**Tender Description:** REPLACEMENT AND INSTALLATION OF FENCE AT THE PORT OF NGQURA AND COEGA  
KOP QUARRY FOR A PERIOD OF 10 MONTHS

**Tender Number:** TNPA/2025/04/0017/94422/RFP

All Questions and Answers from **29 May 2025 to 17 June 2025**

ANNEXURE A1 SECTION 2 PORT OF NGQURA - HOT DIPPED GALVANIZED MESH FENCE ONLY

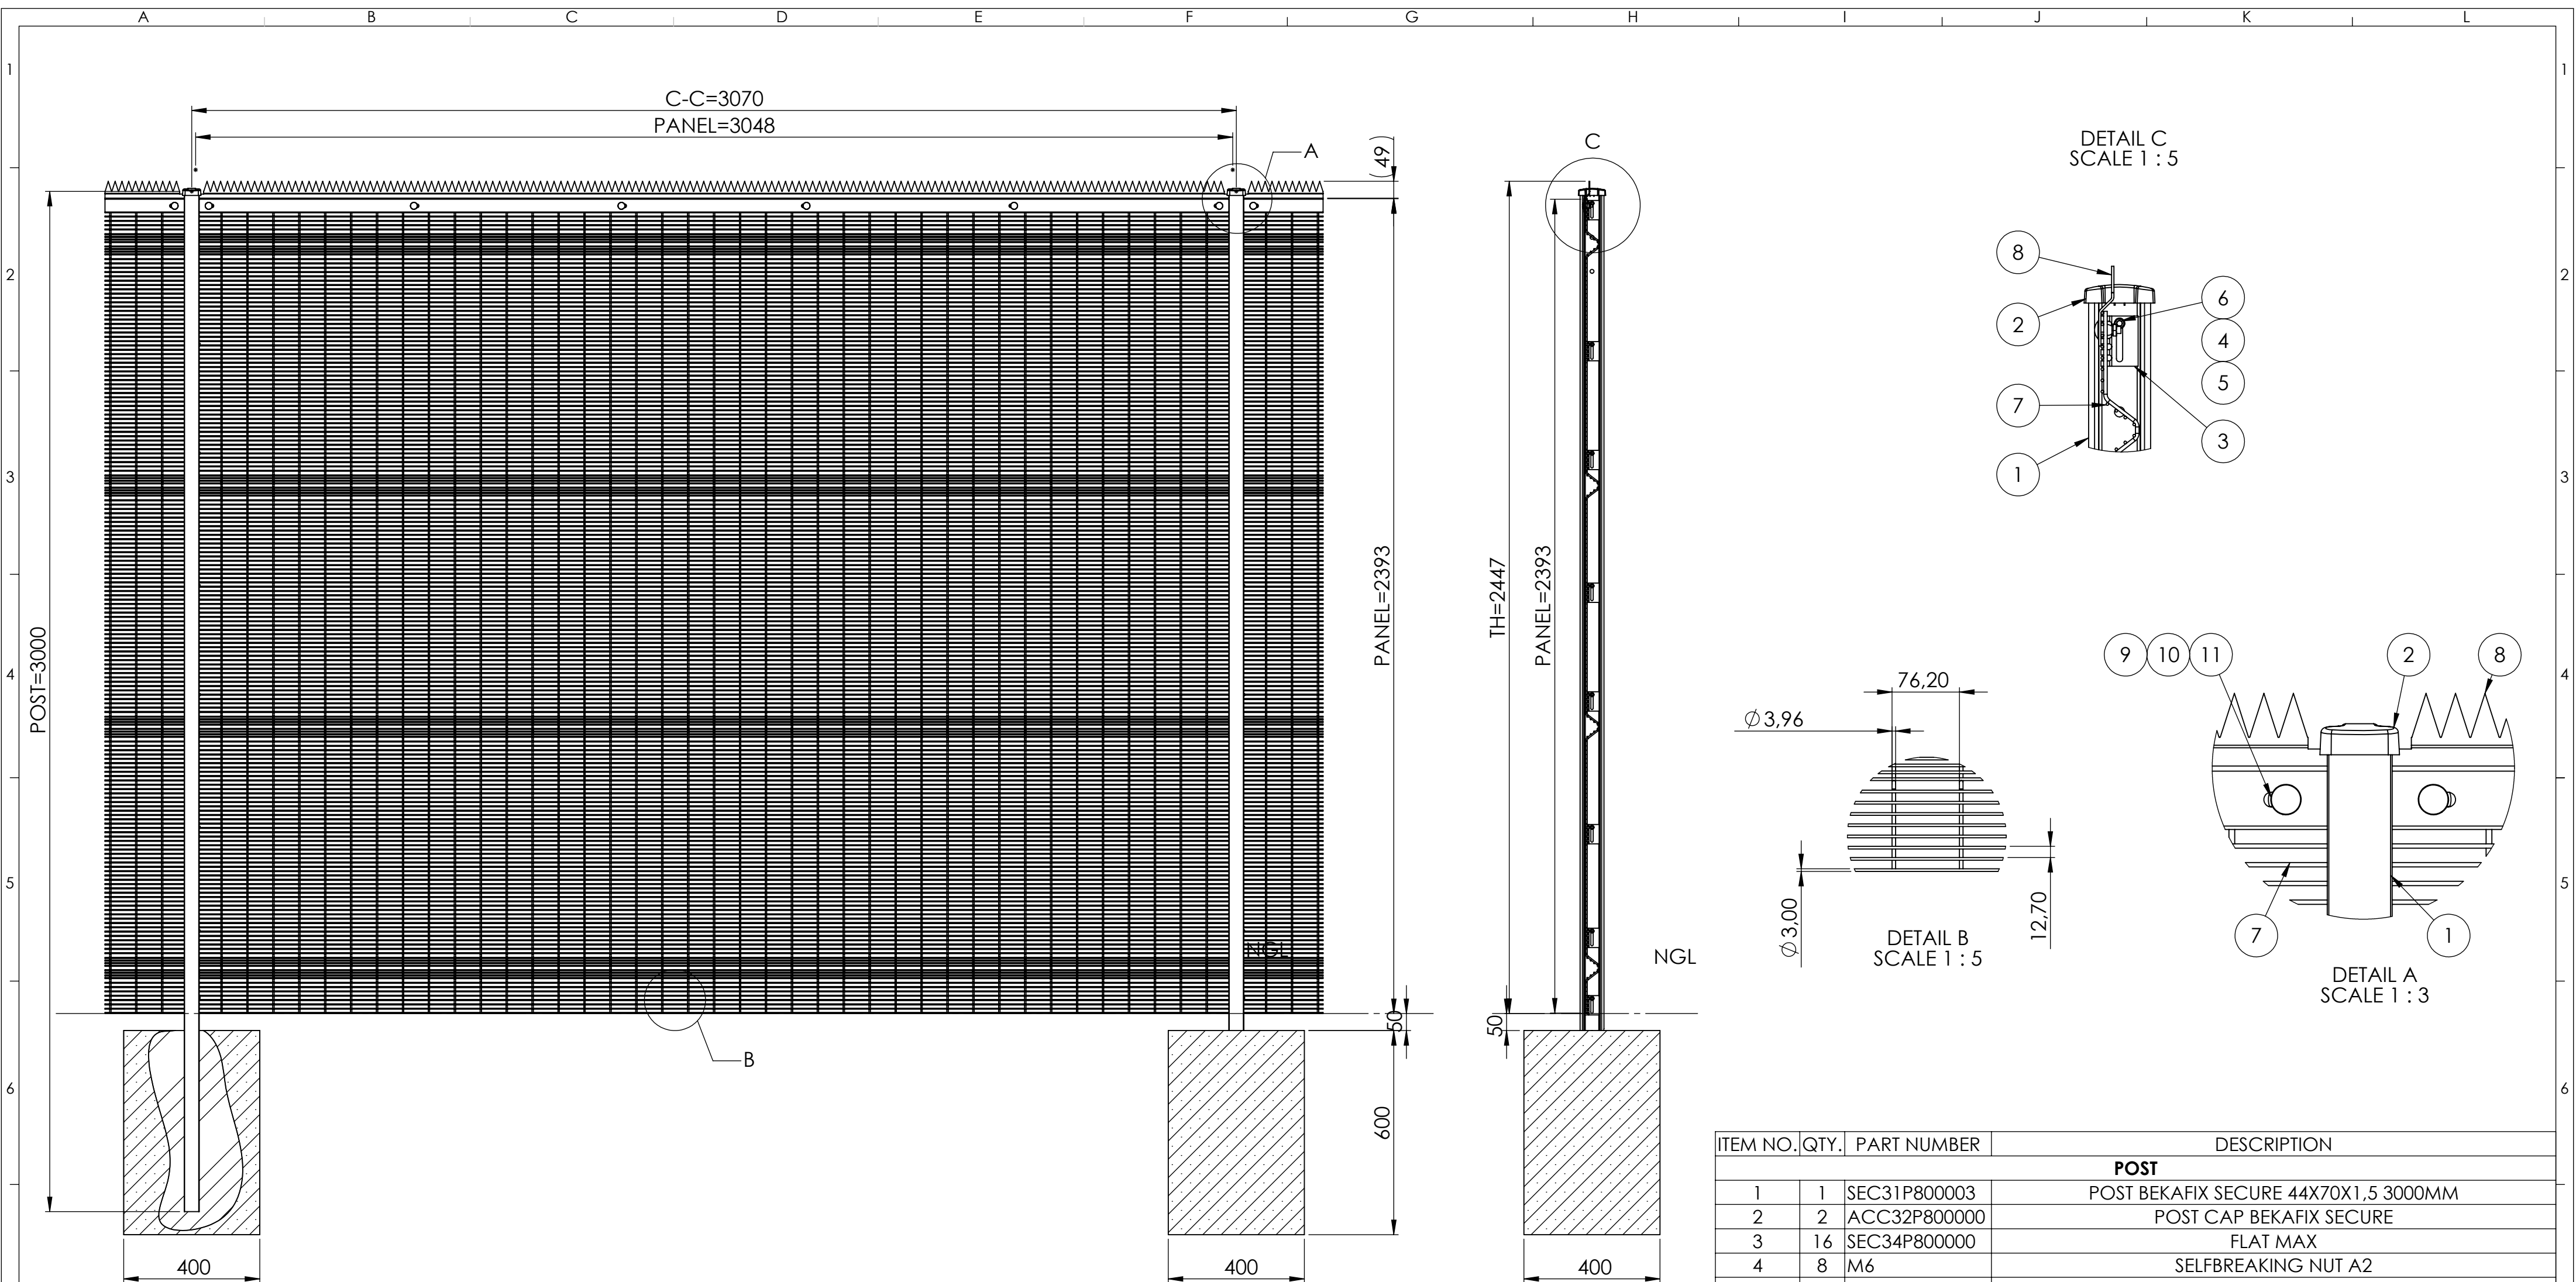
Annexure A1 for Site Establishment for Section 2 Port of Ngqura (Hot Dipped Galvanized Mesh Fence) and Annexure A2 for Free Issue Material attached below

SECTION 1 COEGA KOP QUARRY FOR CONCRETE FENCE SHOULD HAVE ITS OWN SITE ESTABLISHMENT

Site Establishment next to  
Multi Purpose Terminal
